***Emergency Remedial Action  
Construction Completion Report  
Upper Tailings Pile  
Van Stone Mine***

***Prepared for  
Washington State  
Department of Ecology***

***December 26, 2012  
17800-34***

Mark	Description	Date	Appr.	Mark	Date	Appr.
	DRAFT FOR REVISION	8/12/12				
REV. 1	ISSUED FOR CONSTRUCTION	10/12/12				
REV. 2	REVISED WITH	12/26/12				
	POST-CONSTRUCTION NOTES

Drawing Reference Number:  
**G-2**  
Sheet 2 of 6

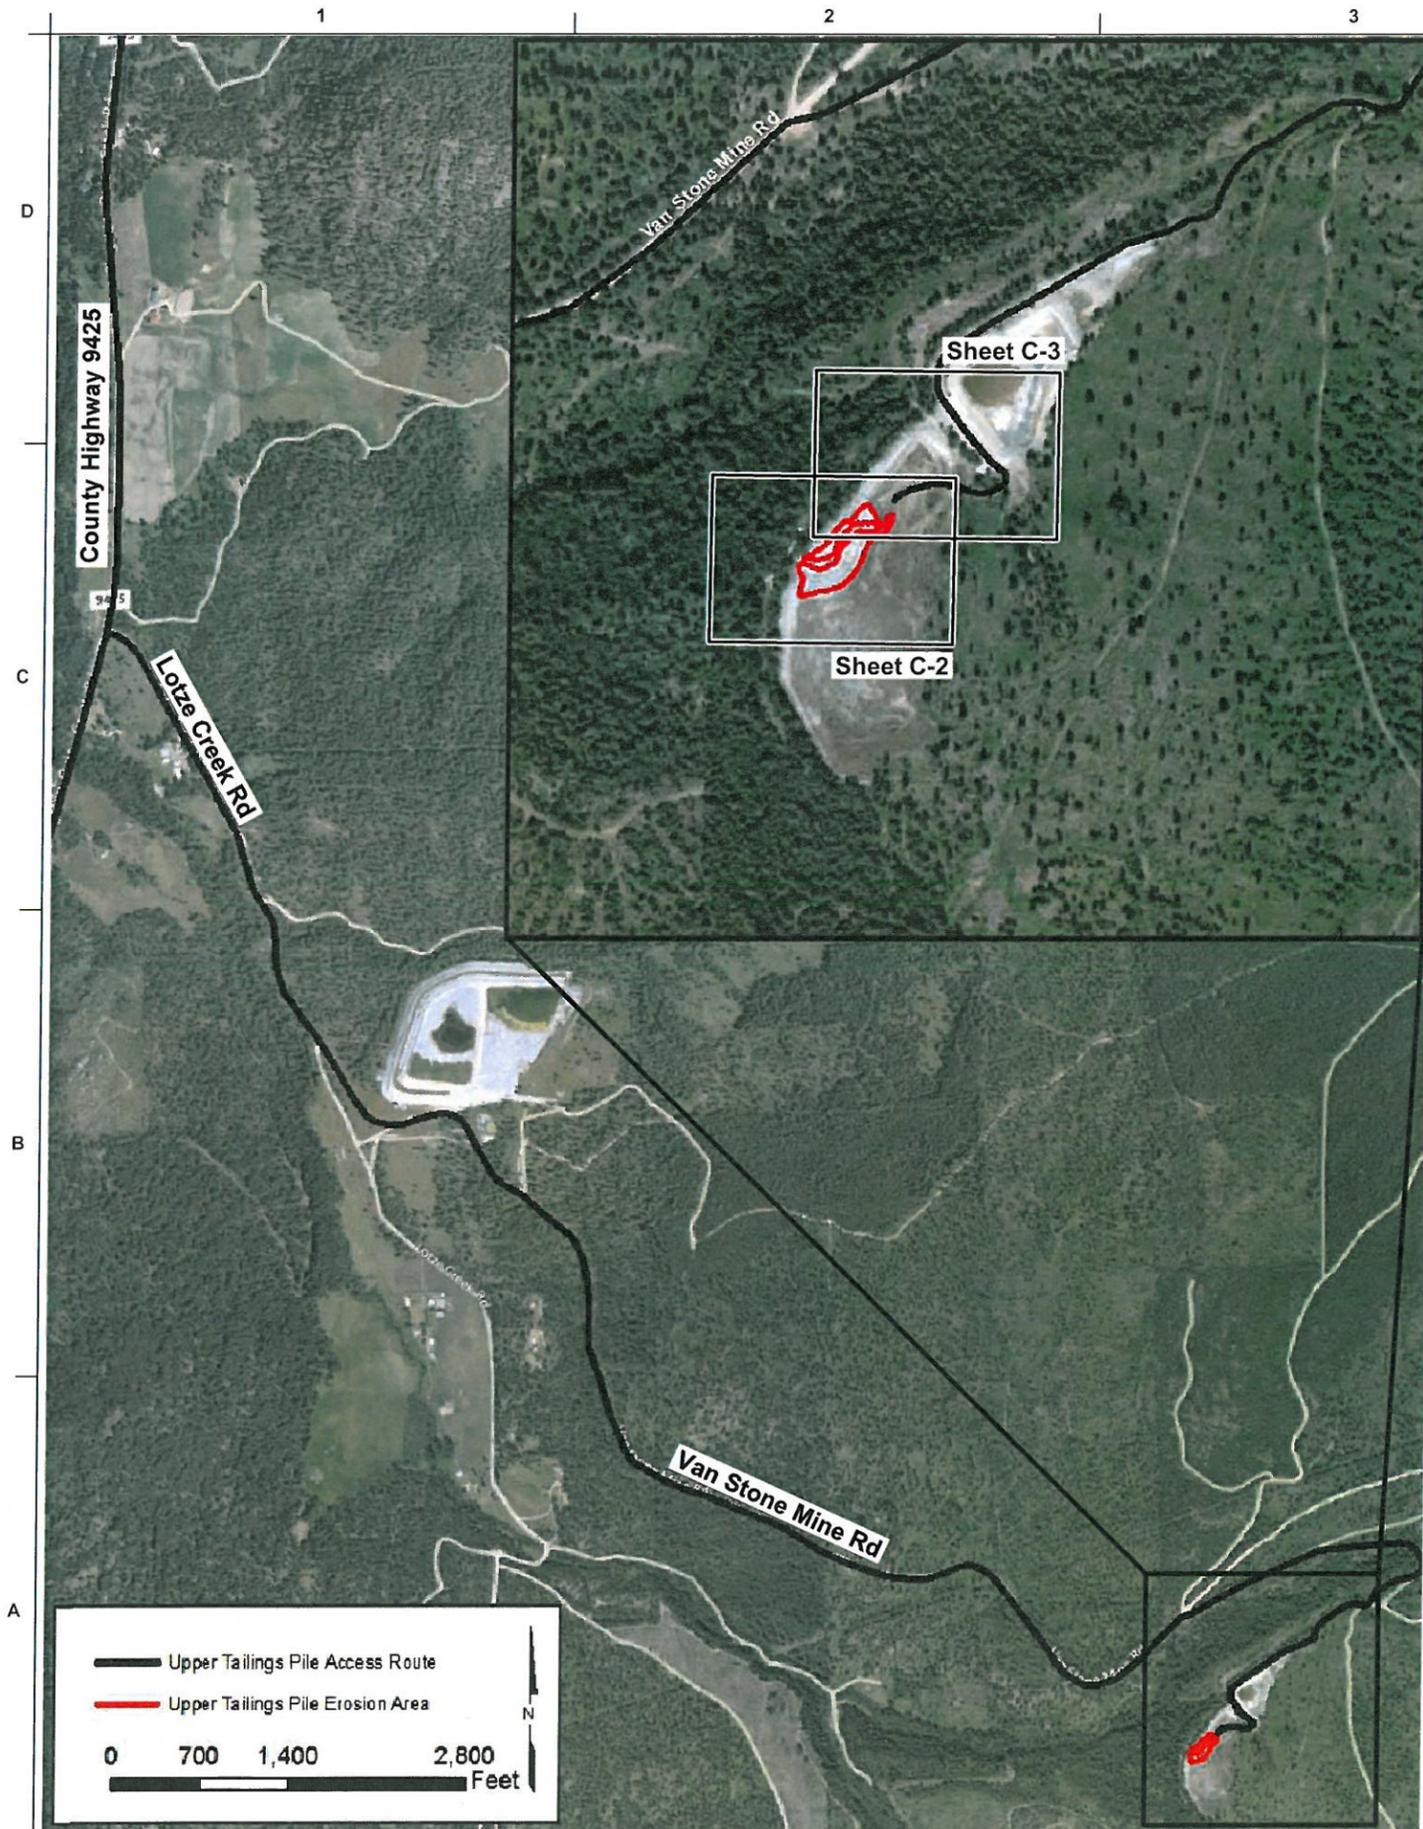
- 1) DUE TO UNAVAILABILITY OF SPECIFIED ROCK MATERIAL AT THE TIME OF CONSTRUCTION, THE CHANNEL WAS LINED WITH A 12-INCH LAYER OF 3-INCH MINUS CRUSHED ROCK TOPPED WITH A 6-INCH LAYER OF 4- TO 10-INCH QUARRY SPALLS.
- 2) 8-OUNCE GEOTEXTILE WAS APPROVED AS A SUITABLE SUBSTITUTE IN THE LOWER HALF OF AREA 2 DUE TO SHORT SUPPLY OF SPECIFIED MATERIAL.
- 3) HYDROSEEDING WAS NOT COMPLETED DUE TO WEATHER CONDITIONS AND EARLY SEASON SNOW COVER.

Drawing Reference Number:  
**C-2**  
 Sheet 4 of 6

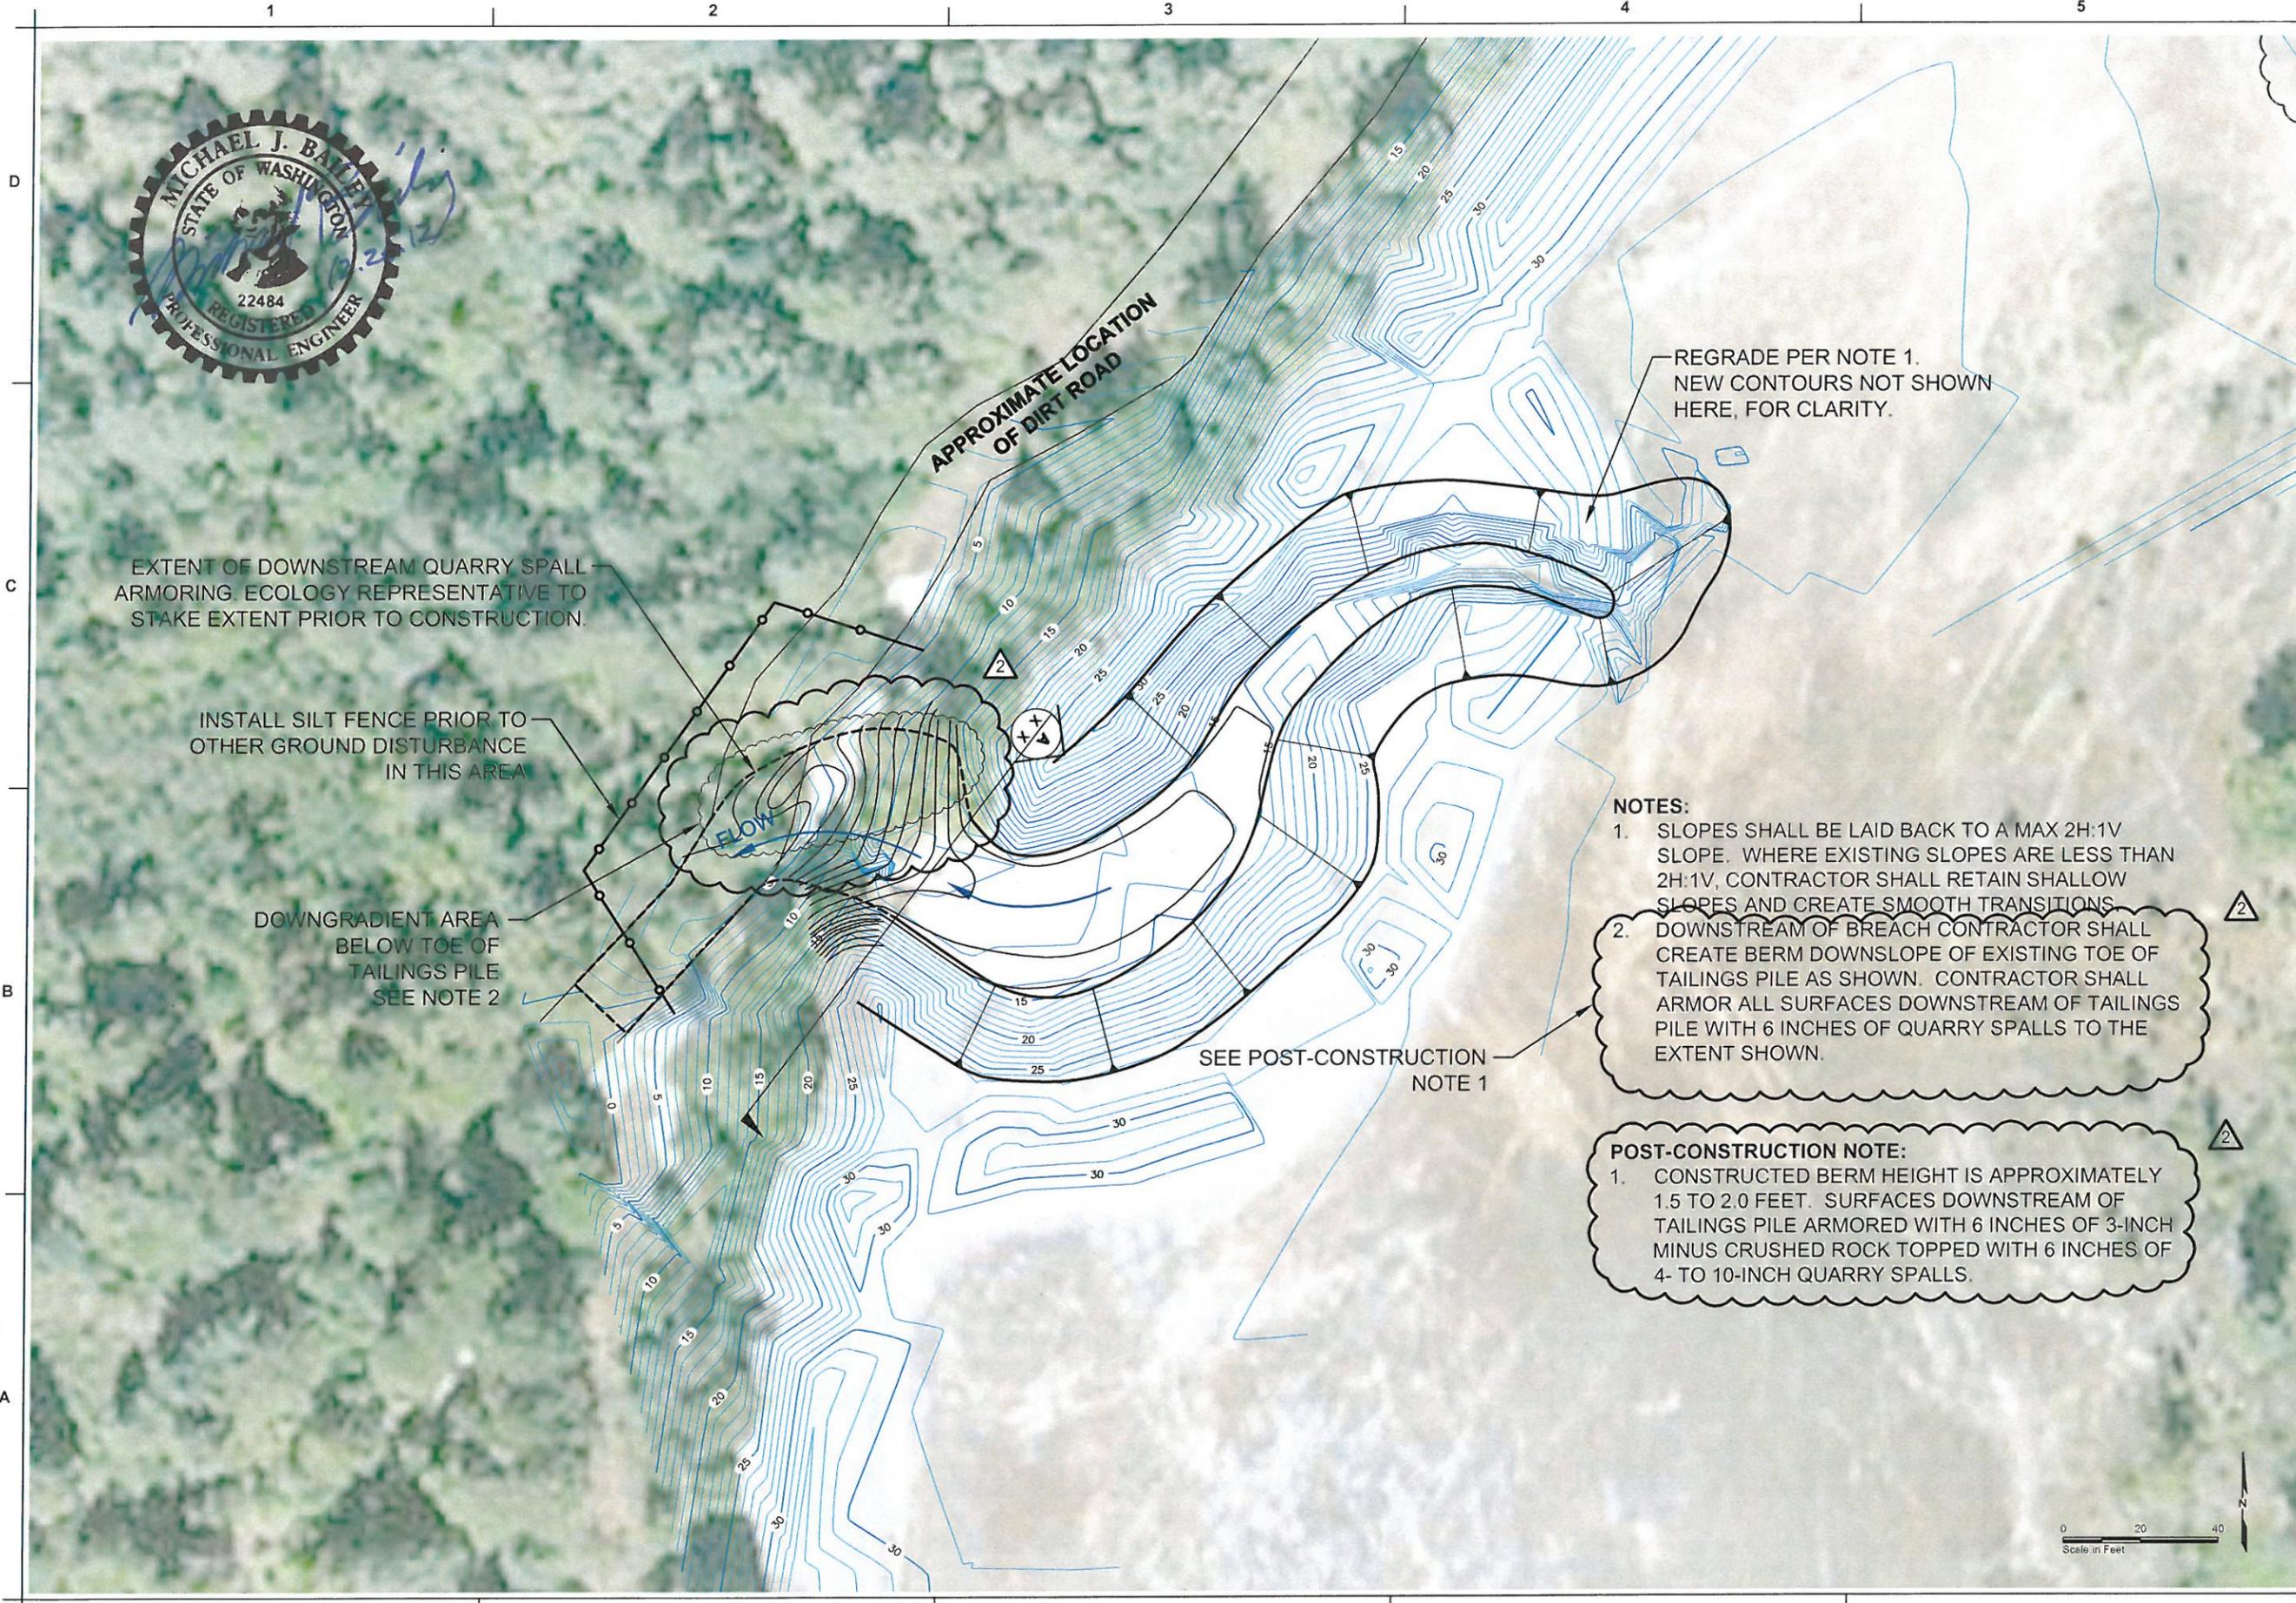
1. CONSTRUCTED BERM HEIGHT IS APPROXIMATELY 1.5 TO 2.0 FEET. SURFACES DOWNSTREAM OF TAILINGS PILE ARMORED WITH 6 INCHES OF 3-INCH MINUS CRUSHED ROCK TOPPED WITH 6 INCHES OF 4- TO 10-INCH QUARRY SPALLS.

SEE POST-CONSTRUCTION NOTE 1

Drawing Reference Number:  
**C-3**  
Sheet 5 of 6

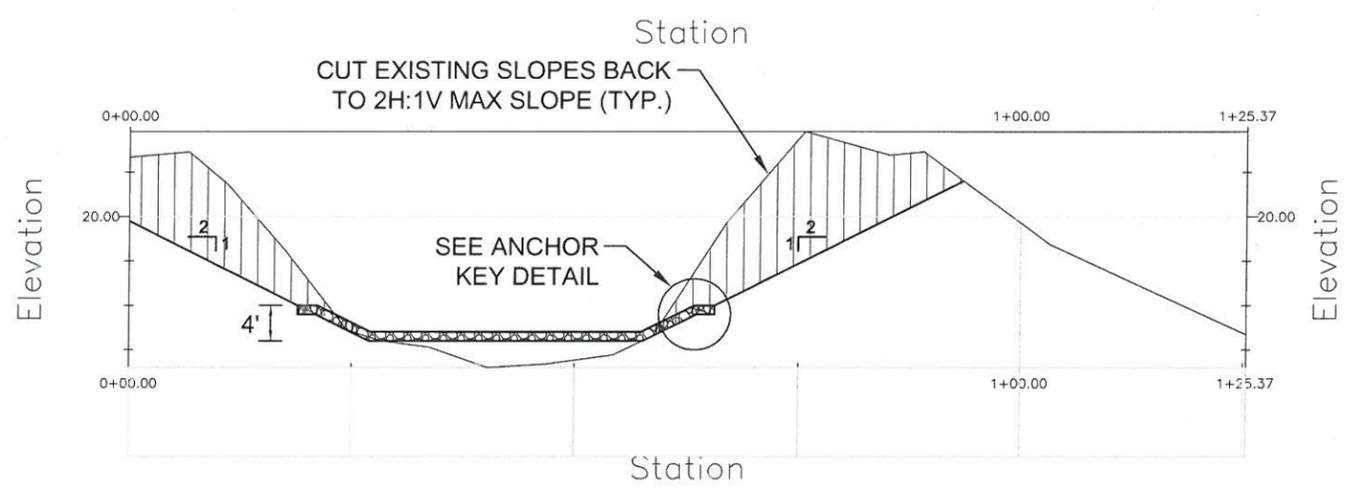
LOWER DRAINAGE CHANNEL AREA  
SEE POST-CONSTRUCTION NOTE 1

1. 8-OUNCE GEOTEXTILE WAS APPROVED AS A SUITABLE SUBSTITUTE IN THE LOWER HALF OF AREA 2 DUE TO SHORT SUPPLY OF SPECIFIED MATERIAL.

Drawing Reference Number:  
**C-4**  
Sheet 6 of 6

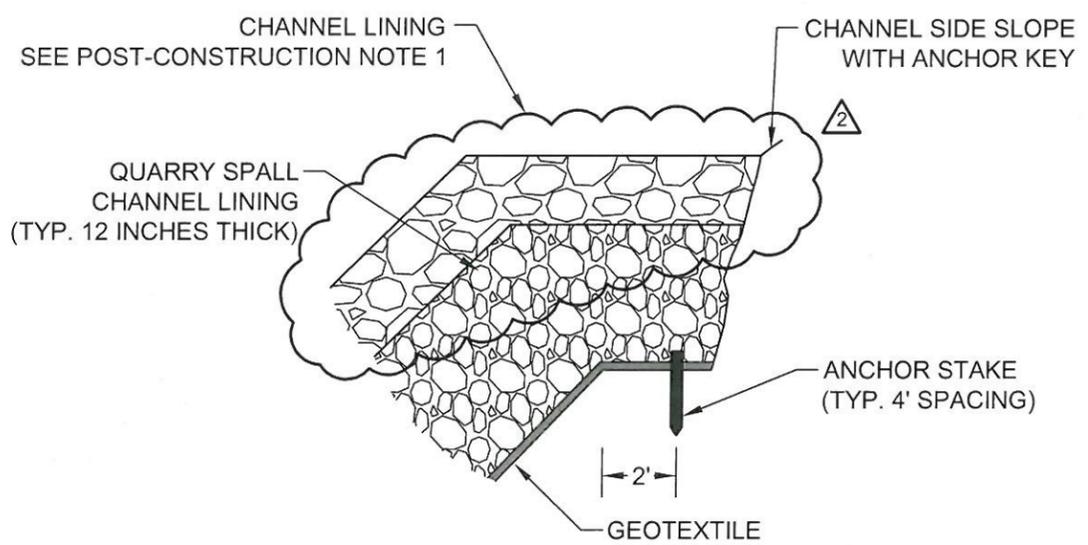
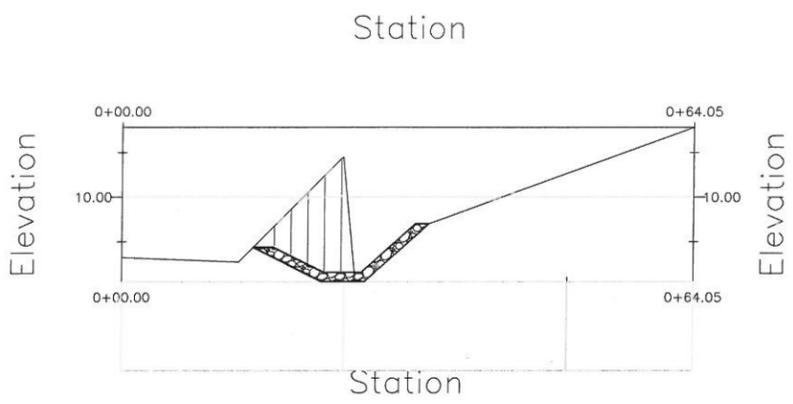
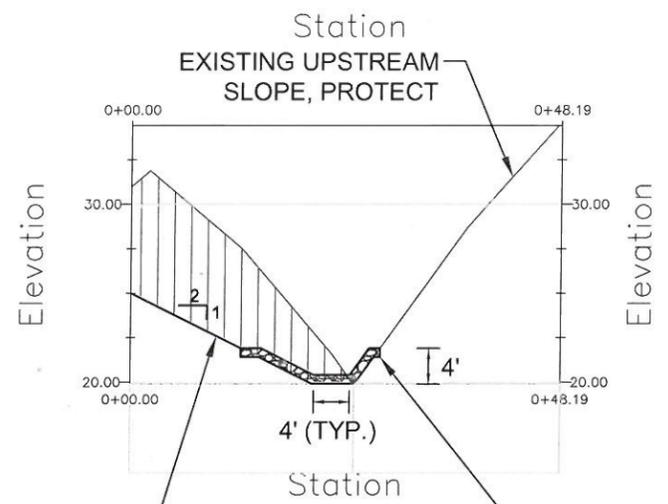
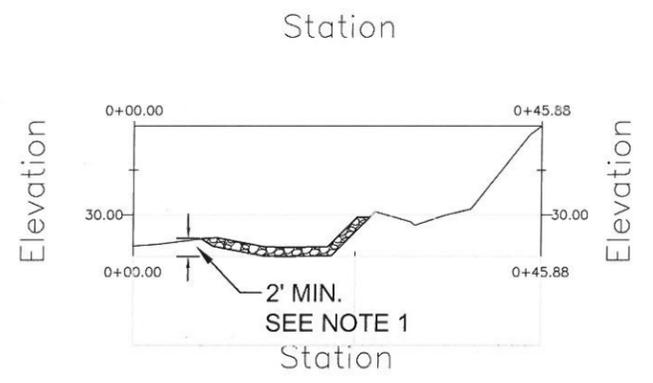
**POST-CONSTRUCTION NOTE:**  
1. DUE TO UNAVAILABILITY OF SPECIFIED ROCK MATERIAL AT THE TIME OF CONSTRUCTION, THE CHANNEL WAS LINED WITH A 12-INCH LAYER OF 3-INCH MINUS CRUSHED ROCK TOPPED WITH A 6-INCH LAYER OF 4- TO 10-INCH QUARRY SPALLS.
